ADDENDUM No. 3

REQUEST FOR QUOTATIONS No.:	1220-040-2024-045
TITLE:	TENANT IMPROVEMENTS OF BRIDGEVIEW CHILDCARE CENTRE
ADDENDUM ISSUE DATE:	SEPTEMBER 5, 2024
CLOSING DATE:	PREFER TO RECEIVE SUBMISSION ON OR BEFORE SEPTEMBER 11, 2024

MC2 SECTION
1 : 10

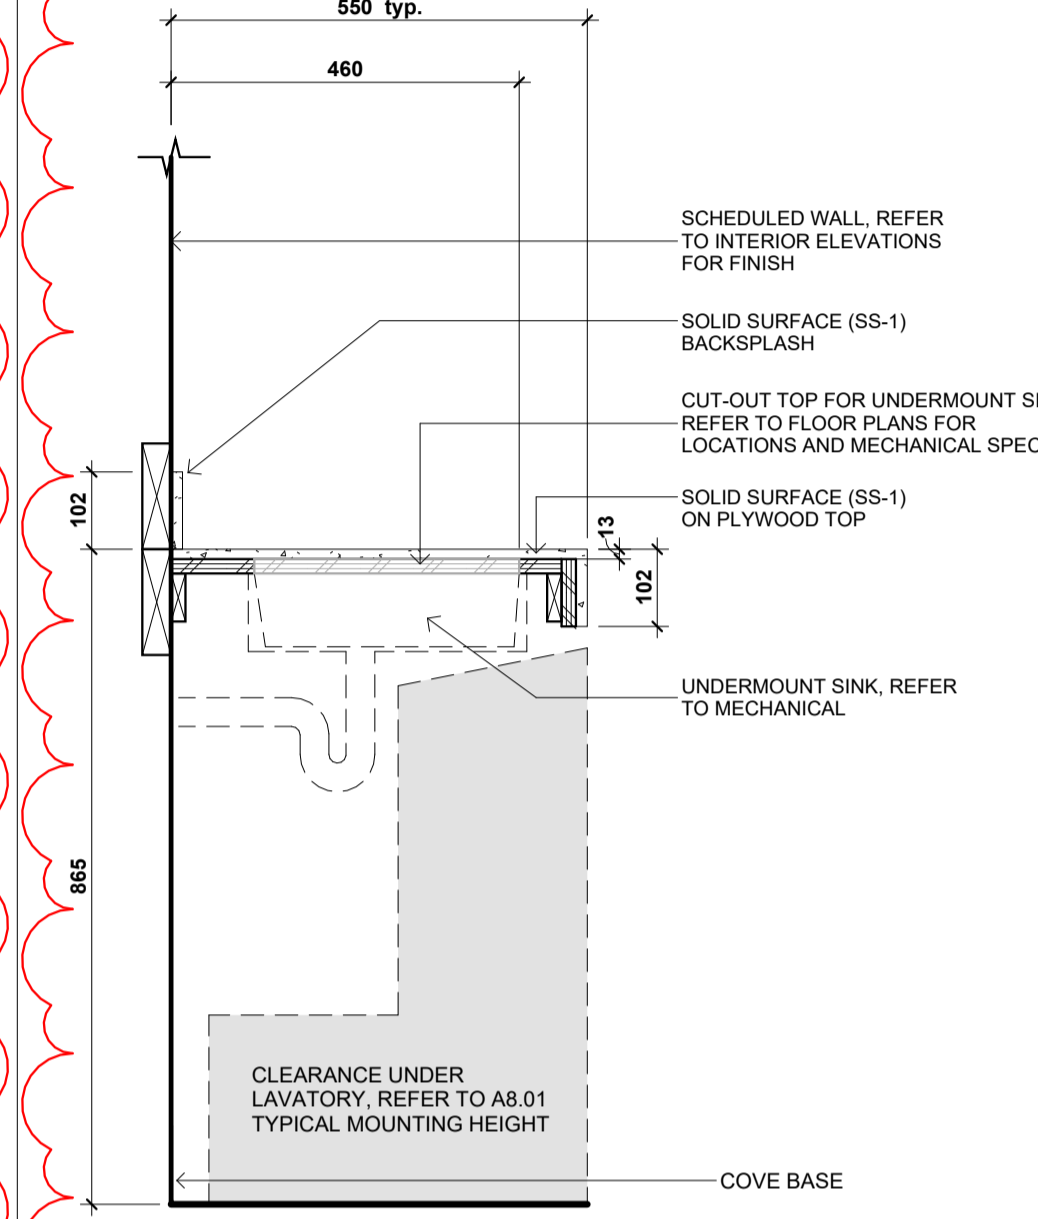
Q3. With reference to Washroom Vanity's DRWG A8.04 / 7 & MC2 section A9.00 / Counter tops solid surface show these being 20mm thick in elevation, but it shows these being 35mm +/- cross section. Please clarify which is correct.

Q4. Vanity Counter top edges show these being 152mm thick in elevation, but show these being 75mm in cross section? Clarify which is correct.

- 6.1 Revised detail MC2 Section on A9.00.

- 9.1 Refer to adjusted sink height in MC2 and detail for countertop edge height.
- 9.2 Refer to new detail MC2a for Vanity Countertop height and thickness.
- 9.3 Refer to CU1 for specs on PVC 3mm edge.
- 9.4 Refer to B1, B2, B3 for drawers and door fronts to go with PLAM on MDF core per AWMAC standards.
